ELECTRICAL—MOISTURE OR CONDENSATION IN FOG LAMPS—VEHICLES PRODUCED BEFORE 6/25/2001	Article No. 01-14-3

FORD: 2001 RANGER

Figure 1 - Article 01-14-3

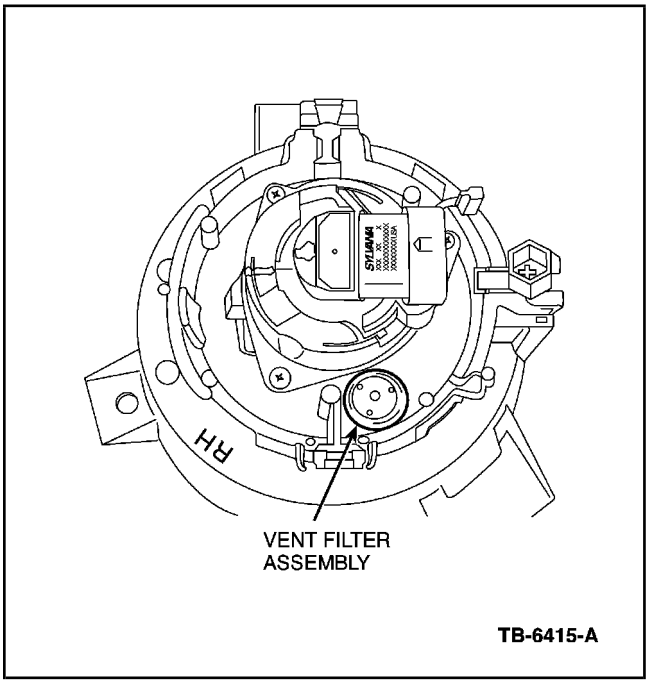
Some vehicles may exhibit condensation and/or water accumulation within the fog lamp assembly. If not serviced, the fog lamp could eventually become inoperative. This may be caused by the fog lamp vent-filter becoming contaminated.

Remove existing fog lamp vent cap and replace with new service fog lamp vent cap. Refer to the following Service Procedure for details.

6. Install new vent filter assembly, cap colored “black” (1L5Z-13B216-AA). Refer to Figure 1.

NOTE
IF OBTAINING A NEW FOG LAMP, VERIFY THAT THE VENT FILTER CAP IS COLORED “BLACK” AND CONTAINS A “NITTO DENKO” TEXT STAMPED IN AND ON-TOP OF THE “BLACK” CAP PRIOR TO INSTALLATION. THIS WILL ENSURE YOU HAVE OBTAINED THE CORRECT COMPONENT.
